**NPDES PERMIT FACT SHEET
INDIVIDUAL INDUSTRIAL WASTE (IW)
AND IW STORMWATER**

Application No. PA0086291
APS ID 326395
Authorization ID 1394946

Applicant Name	Texas Eastern Transmission LP (TETLP)	Facility Name	Texas Eastern Transmission LP (TETLP) – Perulack Compressor Station
Applicant Address	PO Box 1642 Houston, TX 77251-1642	Facility Address	Perulack Compressor Station 3318 Pumping Station Road East Waterford, PA 17021-7187
Applicant Contact	Niti Tottempudi	Facility Contact	Ian Ivy
Applicant Phone	(713) 627-5967	Facility Phone	(713) 627-6445
Client ID	82786	Site ID	442911
SIC Code	4922	Municipality	Lack Township
SIC Description	Trans. & Utilities - Natural Gas Transmission	County	Juniata
Date Application Received	May 3, 2022	EPA Waived?	Yes
Date Application Accepted	May 12, 2022	If No, Reason	
Purpose of Application	NPDES Renewal for discharges from a Groundwater Treatment System (GWTS) / Groundwater Remediation System (GRS)

Figure 2. Water Balance – Line Diagram. (Source: Figure 2 from the 5/28/2024 Response to Technical Review Questions document received via email on 5/28/2024)

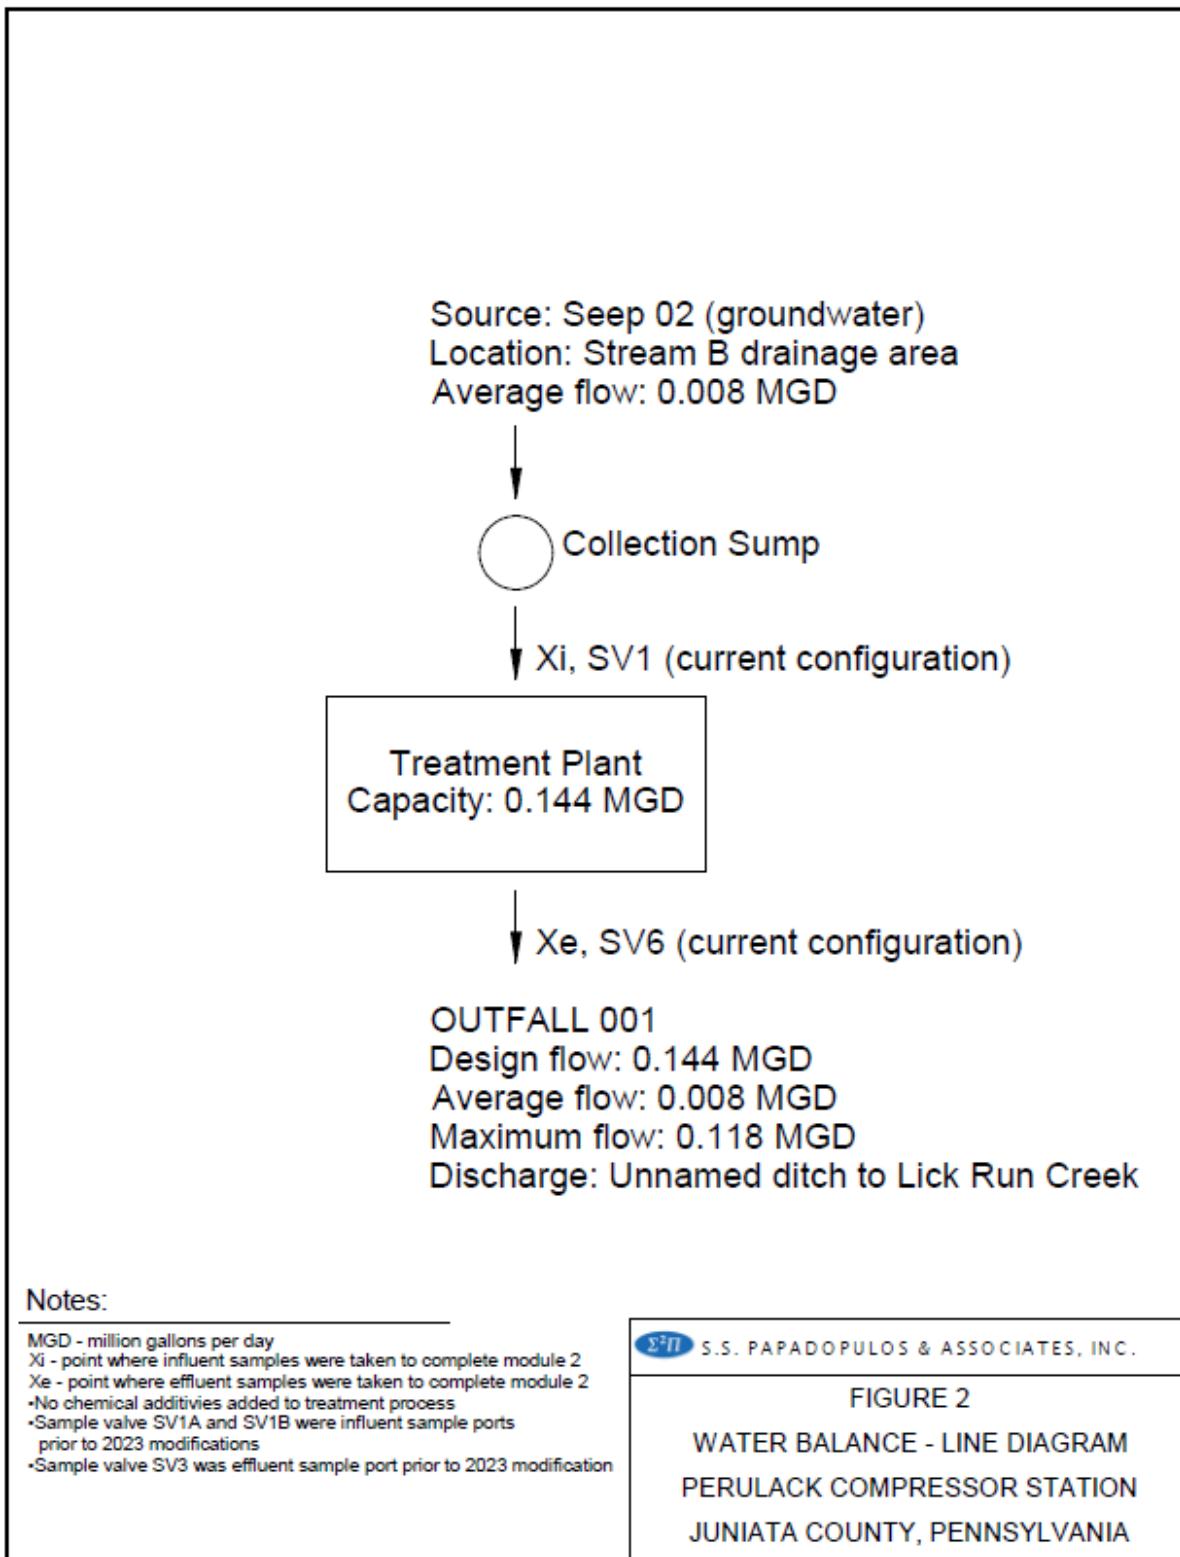
System Description page (Description page; included with the application); shown on Figure 2 Water Balance – Line Diagram (in the renewal application); what is shown on the Site Layout (Figure 3 in the application; and Figure 1 in the 2/15/2024 Construction Completion Report); and illustrated on Figure 2 Water Treatment System Configuration (in the 2/15/2024 Construction Completion Report). I have attached 2 files: 1 with the Description Page, Figure 2 Water Balance Diagram, and Figure 3 Site Layout from the renewal application; and 1 with Figure 1 Site Layout and Figure 2 water Treatment System from the 2/15/2024 Construction Completion Report.

6b: The Description page states: The wastewater treatment system is designed to remove PCB impacted groundwater from Stream B drainage area (Seep 2). "Stream B Drainage Area" as shown in the INSET of the Site Layout appears to be something separate from Seep 02. Seep 2 isn't shown on the Figure 2 Water Balance Line Diagram (renewal application). And Water from Seep 02 is shown as the input to the collection sump in Figure 2 Water Treatment System Configuration (in the Construction Completion Report) on Is the Stream B drainage area the same or different from Seep 02?

collected and gravity drained to the collection sump. The water line diagram has been updated to clarify the source is only Seep 02 (Figure 2).

Figure 3. Site Layout. (Source: Figure 1 from the 5/28/2024 Response to Technical Review Questions document received via email on 5/28/2024)

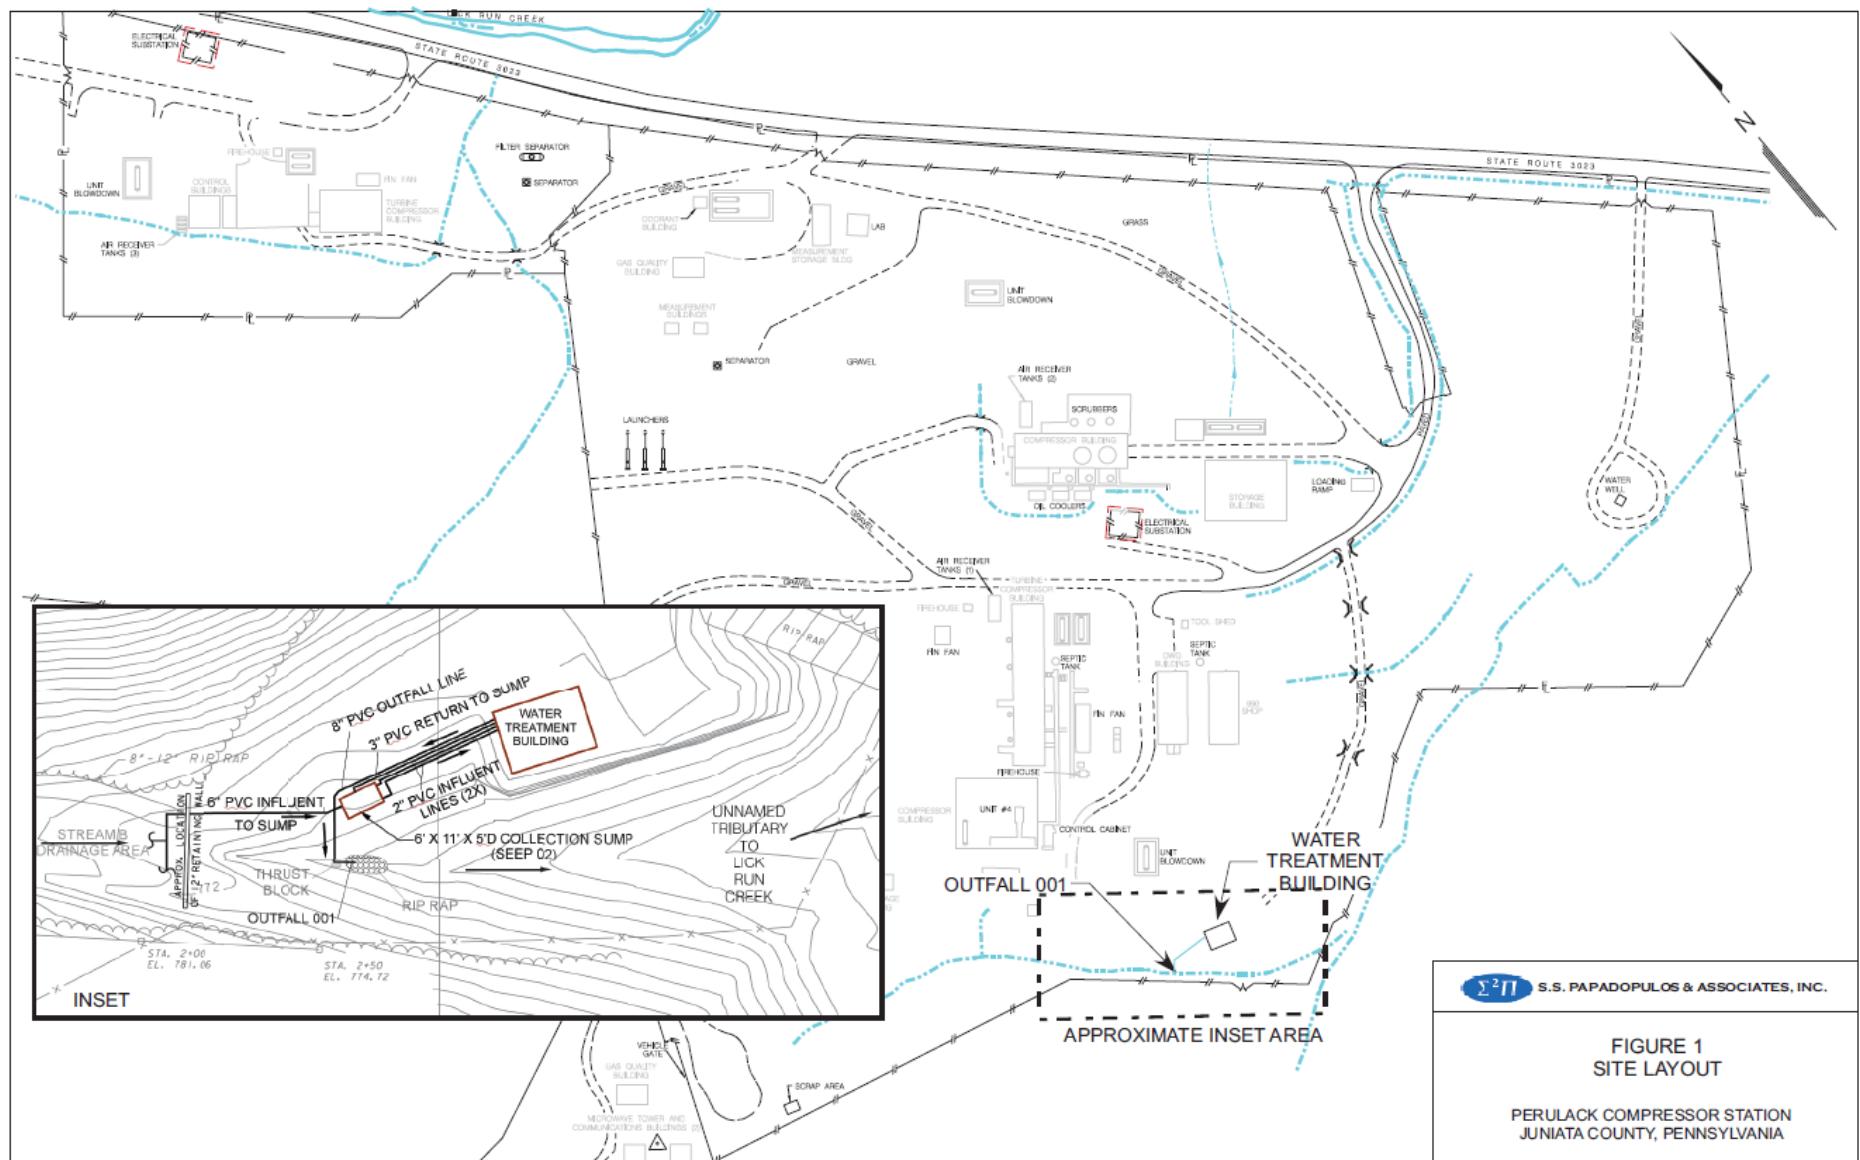
June 4, 2024 – Upon review of the 5/28/2024 responses, PADEP sent an email with more questions regarding the exact location of Outfall 001 and request for further clarification on some of the 5/28/24 responses. I included a PDF of a screenshot from Google Earth Pro that I marked up to facilitate my questions. I requested a site visit to help visualize the treatment system and path of contaminated groundwater from its source to the point of discharge. (**Attachment E**)

- b. According to the Figure 1 Site Layout included with the responses, Outfall 001 is located somewhere to the east of the Water Treatment Plant Building.

June 4, 2024 – PADEP received an email response from Enbridge to the questions which included updated Outfall 001 coordinates along with plans to schedule a site visit to help facilitate my understanding of the system. (**Attachment F**)

- Coordinates for Outfall 001 were revised per June 4, 2024 response email (previous coordinates incorrectly placed the outfall among the compressor station buildings).
- Note: improvements to the treatment system in late 2023 did not affect Outfall 001

Figure 4. Water Treatment System Configuration. (Source: Figure 2 received via email on 6/25/2024)

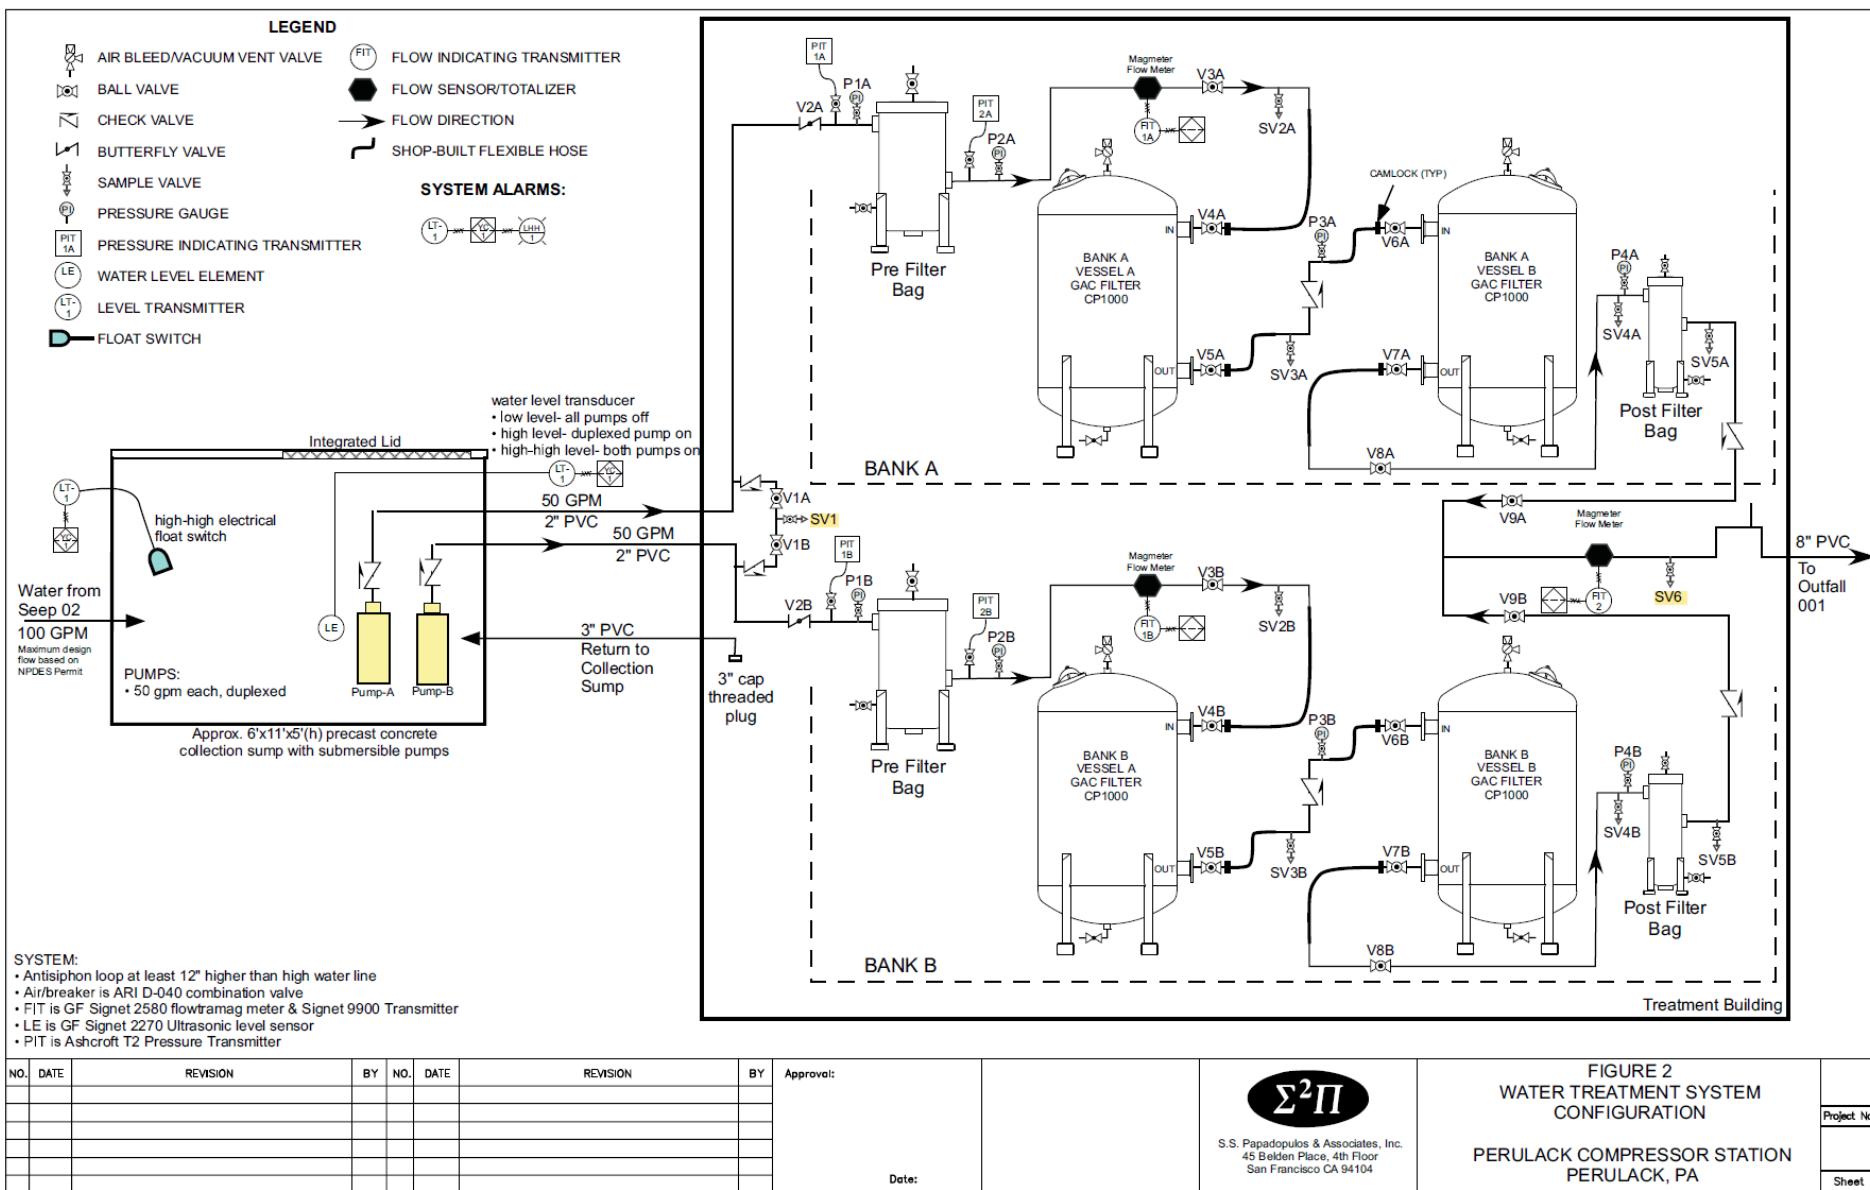
June 11, 2024 – PADEP conducted a site visit. I requested an updated Figure 2 Water Treatment System Configuration (found in the February 15, 2024 Construction Completion Report) that included labels for the sample valves (SV1 and SV6).

Total PCBs are sampled quarterly in the influent (untreated, SV1) and effluent (treated, SV3 (SV6 with the 2023 modifications)) to the remedial system. SV1 and SV6 are shown in **Figure 4 Water Treatment System Configuration** (received 6/25/24 via email).

June 25, 2024 – PADEP received an email from Enbridge with a revised Figure 2 Water Treatment System Configuration, with all valves labelled, and SV1 and SV6 highlighted to help identify them in an email from Enbridge. **See Figure 4.**

Attachment E. Page 3 of 3.

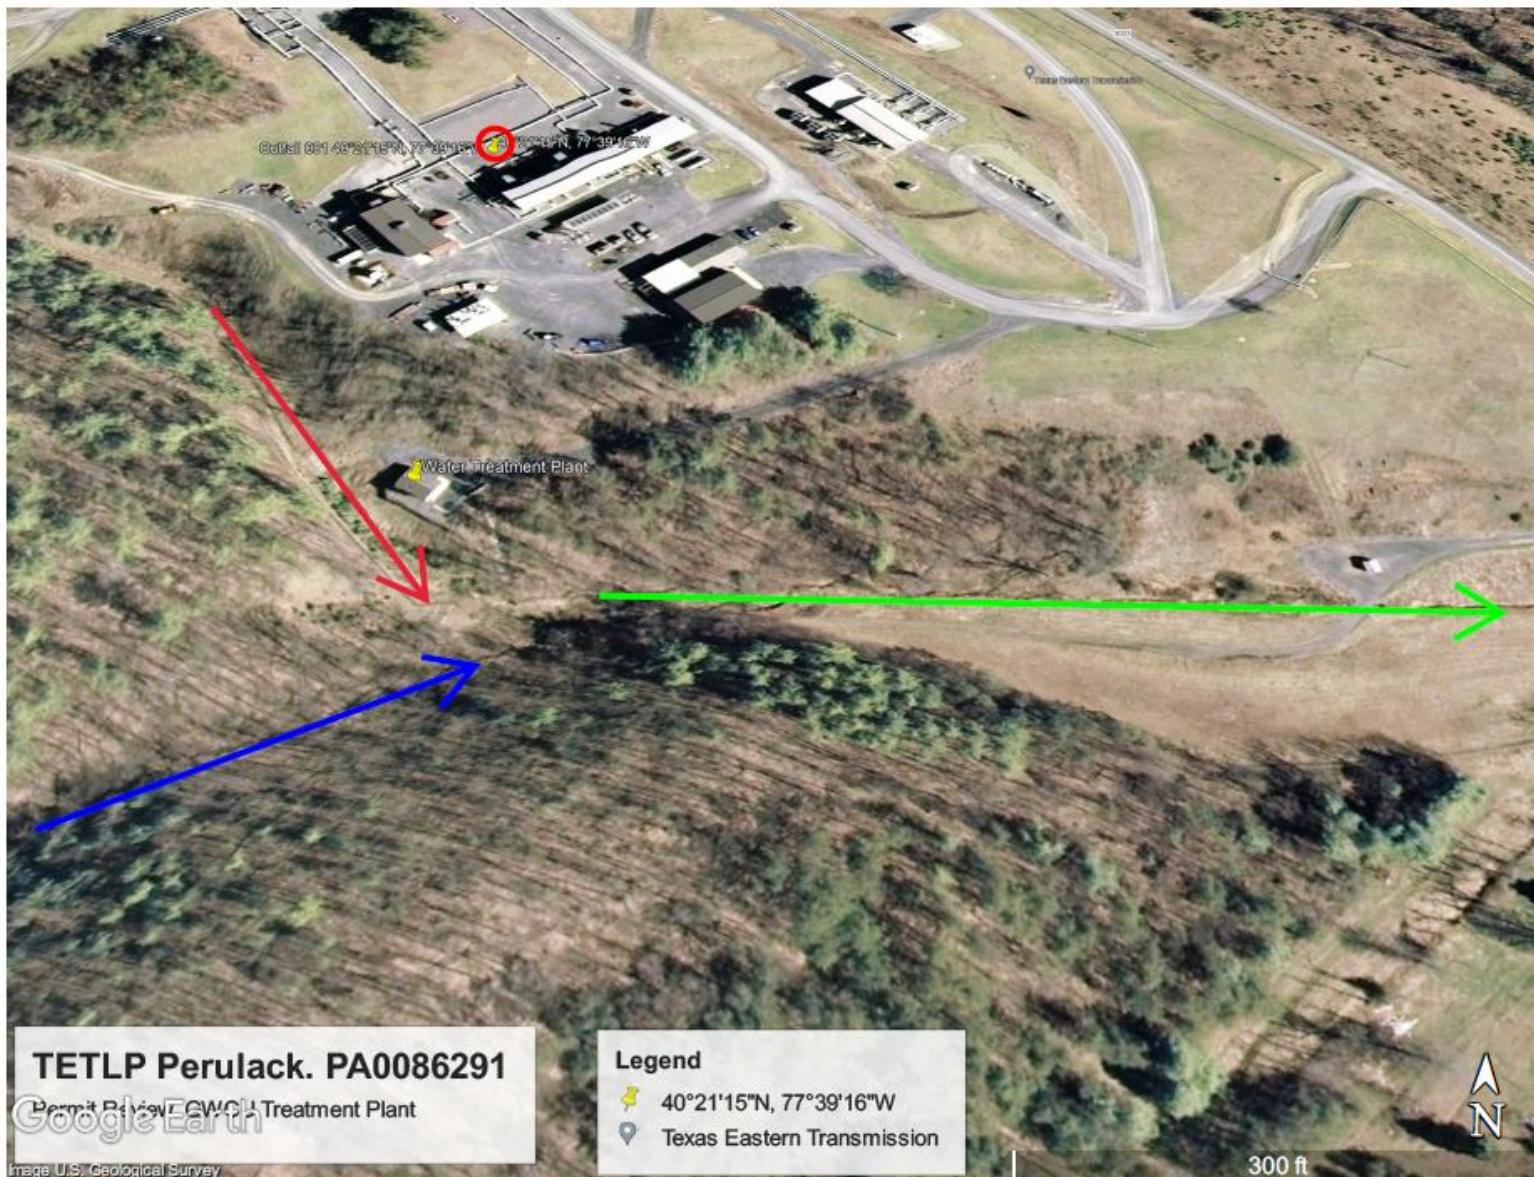
I have some questions on the attached PDF that I saved from Google Earth Pro, which gave me better perspective on the topography (I used imagery from 3/2007 because it was the easiest image for me to see the topography – less trees in bloom).

1. Please confirm that I have properly identified the Water Treatment Building (Plant) on the attached PDF. Marked with a yellow pushpin.
2. Outfall 001 Coordinates:

- c. Please indicate the location of Outfall 001 on the attached PDF; along with the associated coordinates.
3. RED ARROW drawn on attached PDF:
 - a. Please verify if the RED ARROW is in the approximate location of the Stream B Drainage Area (Stream B Valley).

- b. Does the RED ARROW indicate the location of the ravine mentioned in Q5 Answer?
 - c. Per Q6b Answer, Stream B is a dry drainage channel that only carries surface stormwater runoff. Does the RED ARROW on the attached PDF correctly represent Stream B?

4. Could you indicate the approximate location of the Retaining (capture) wall (aka barrier wall) intercepting Stream B Valley on the attached PDF (as noted in Q5 Answer)?

Yes of course, we can schedule a site visit for you to look at the collection and treatment system components. As you suggested, it will probably be best to visit the site which will help clarify the layout and the location of Stream B, the weir, collection sump, outfall, etc. and answer most of your questions. Please propose couple of dates for the site visit as per your schedule and convenience, we will check with the site operations supervisor and confirm with you.
